## RECORD OF TECHNICAL CHANGE

Technical Change No. 2

Project/Job Name Industrial Sites/ Corrective Action Unit 240

The changes specified in this Record of Technical Change apply to Section 4.4 and Figure 4-2 of the *Corrective Action Investigation Plan for Corrective Action Unit 240: Area 25 Vehicle Washdown Nevada Test Site, Nevada*, Revision No. 0, January 1999; DOE/NV--532. These changes are necessary to allow the collection of soil samples using a backhoe at Corrective Action Site (CAS) 25-07-02. This collection method will be used in the gravel sump at this CAS because the gravel within the sump is deeper than originally anticipated.

**Figure 4-2**  
**Sample Locations CAS 25-07-02 Vehicle Washdown Area (F and J Roads Pad)**  
**Area 25 Nevada Test Site**

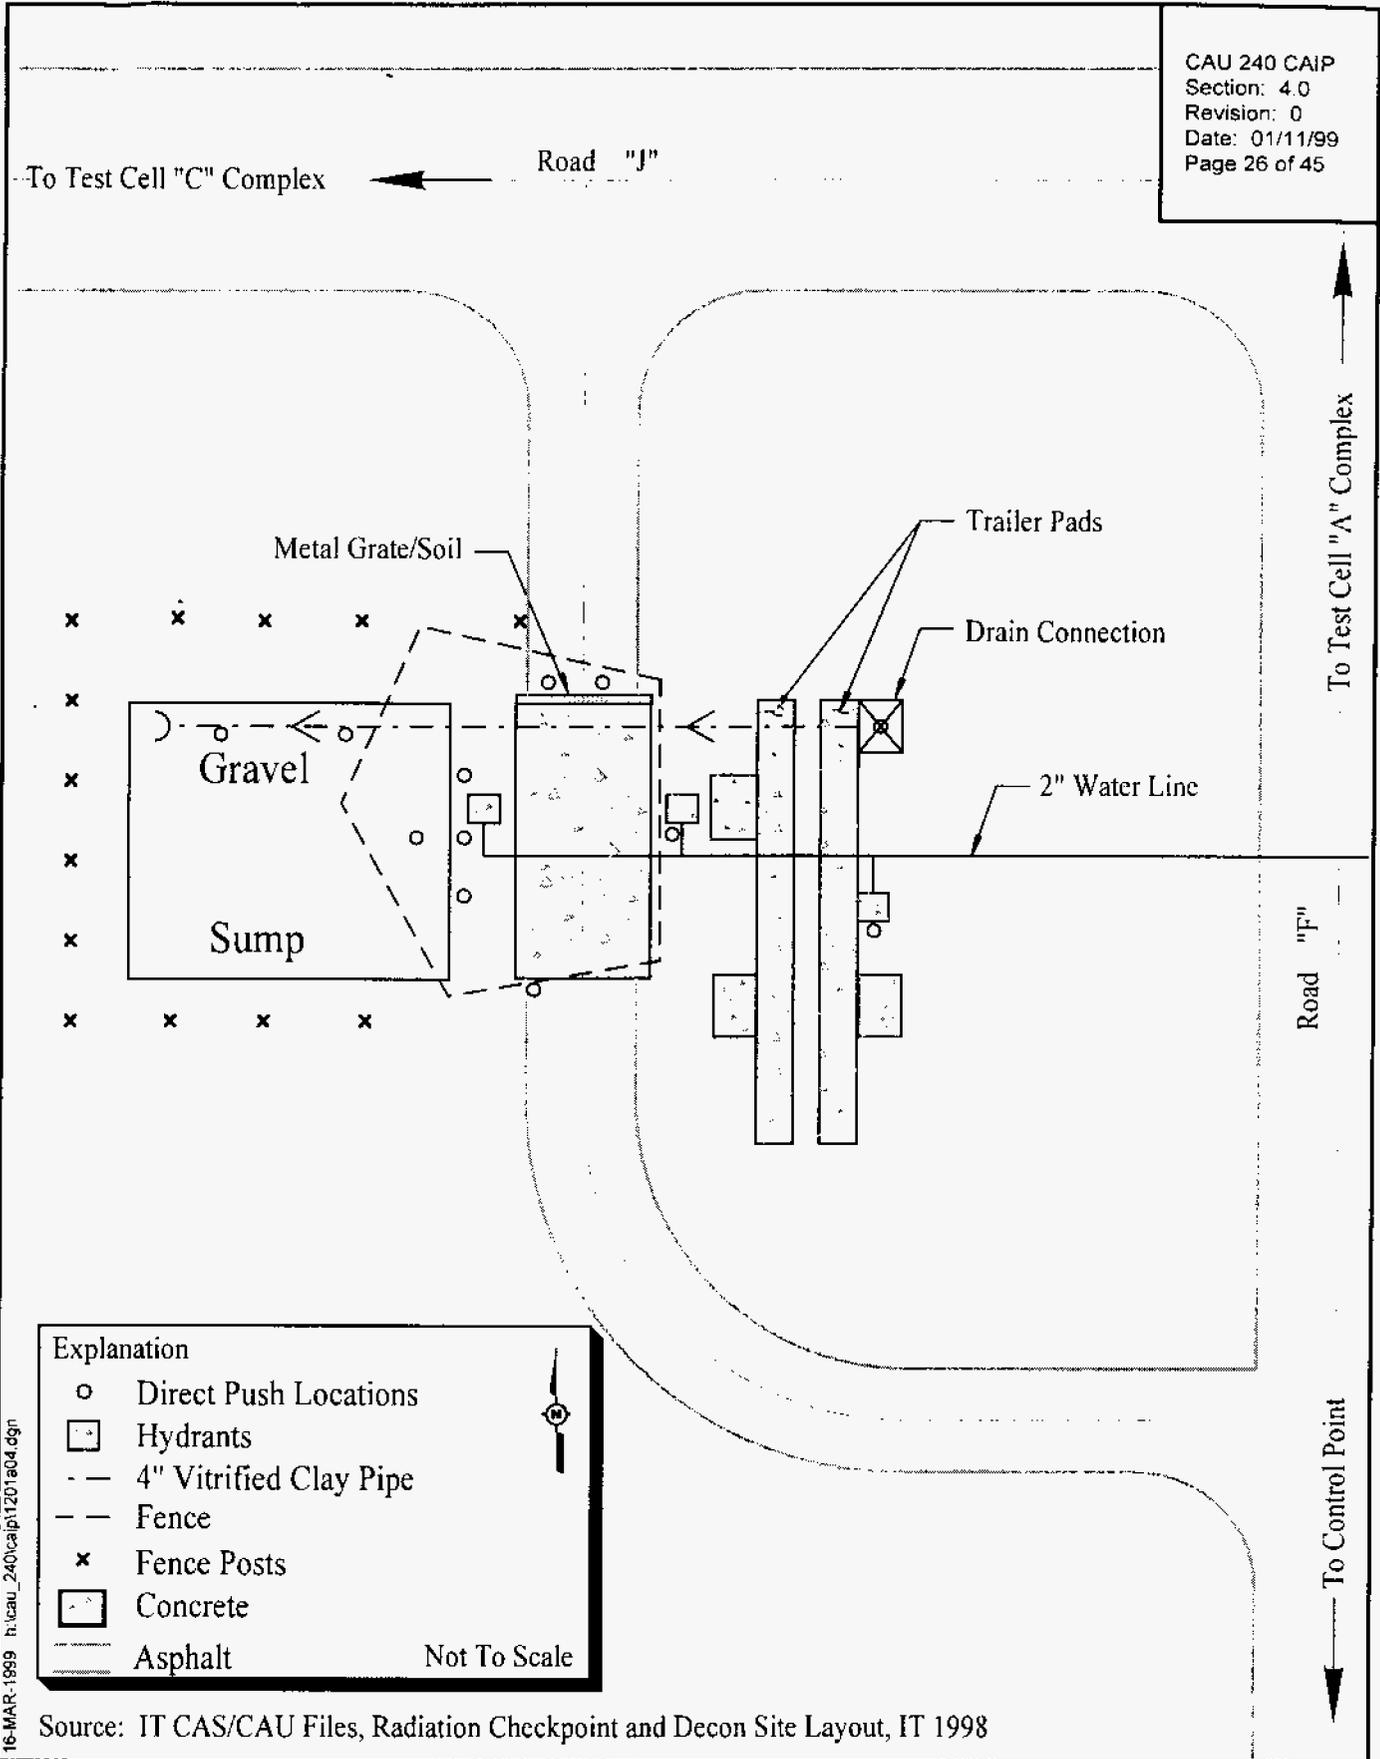
**Figure 4-2**

Replace with the attached Figure 4-2 which shows the approximate sampling locations in the gravel sump.
